Updated Field Safety Notice

MR systems with SW versions R11.1 and R12.1
MobiView cross reference alignment errors

May 2026

Figure 1. Cross reference line of the axial image (left) is at the incorrect location on the MobiView generated image (middle). The correct location is shown on the non-fused sagittal source image (right).

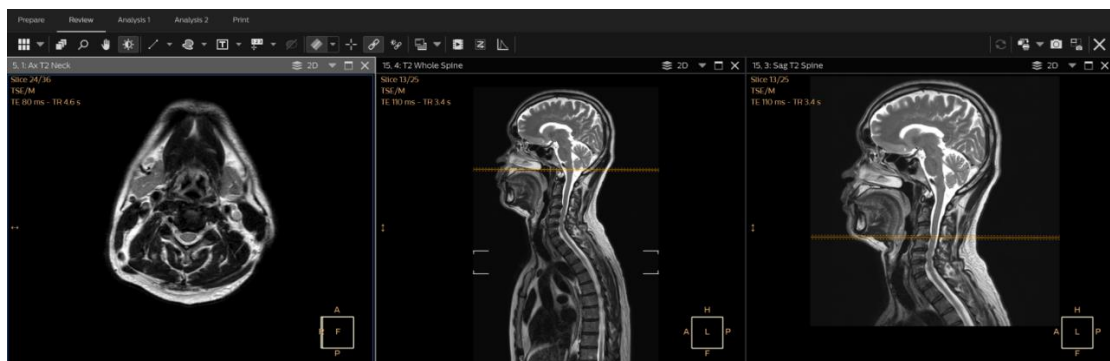
- A. The cross reference line and/or box may be shown at an incorrect location when displayed on a MobiView generated image (see examples in Figure 1 and 2).

The alignment errors may occur only if both of the following conditions are met:

- Multi-station scans that require stitching 3 or more station images, and
- Scan protocol is used where stations have different voxel size or field of view (i.e. voxel size or field of view is customized based on anatomy per station).

- You may continue to use your system(s) in accordance with the intended use.
 - A. To avoid the potential issue of an incorrect cross reference line in MobiView generated images, use the same voxel size and field of view across all station scans.
 - B. Do not use cross reference line functionality in box mode, all slices mode, or 3D mode. Use the cross reference line functionality in single slice mode.
- Circulate this notice to all users of this device so that they are aware of the issues and associated hazard/harm.
- Please retain this Field Safety Notice with your system(s) until the software upgrade is installed; ensure the notice is in a place likely to be seen/viewed.

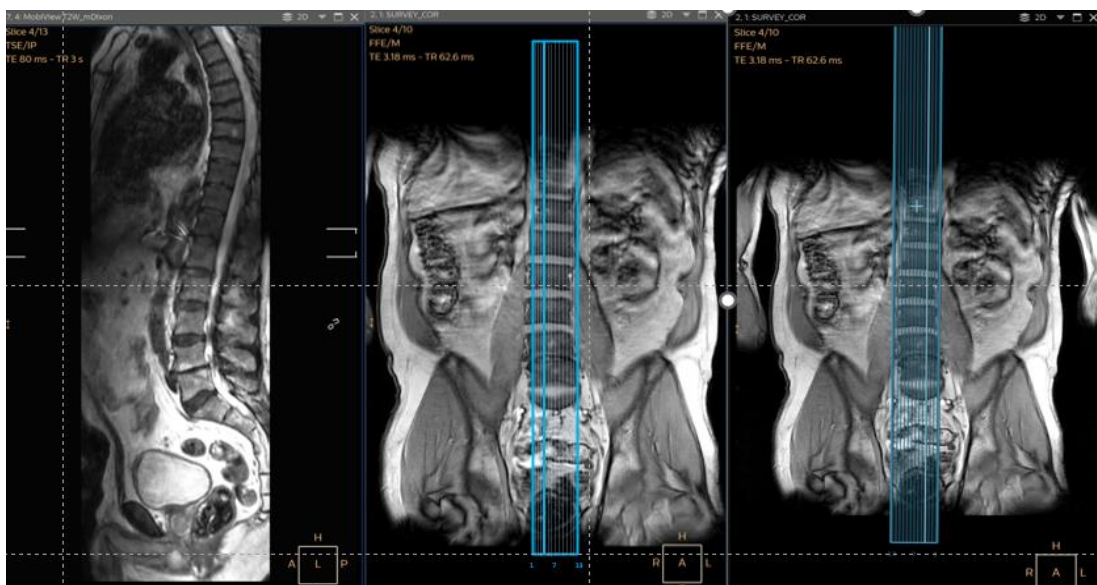
- B. The cross reference box of a MobiView generated image may be shown at an incorrect location when mirrored on to another image (see examples in Figures 3 and 4), if:
- the MobiView images are acquired with reversed slice scan order (i.e. image display settings are customized), or
 - displaying the cross reference box of a MobiView generated merged series (axial stations), or
 - displaying the cross reference box of multi-planar reformats generated from multi-stack data.
